Recall Campaign 09V-474: Inspect Tire Information Placard

Cooper and Cooper S (R56)

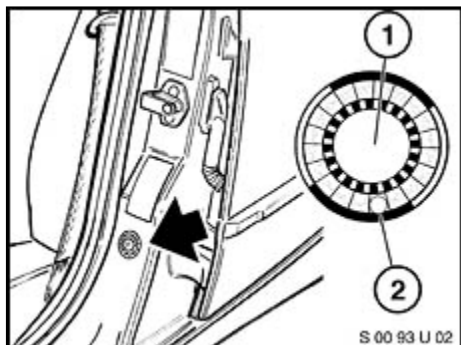
Open the driver's door and inspect the Tire Information Label located on the B-pillar. The affected vehicles were produced with 205/45 R17 Tires.

If the tire size listed on the label is 205/45 R17, no further action is necessary.

If the tire size listed is not 205/45 R17, wipe off the label with a clean, lint-free cloth and apply a new label directly over the existing label.
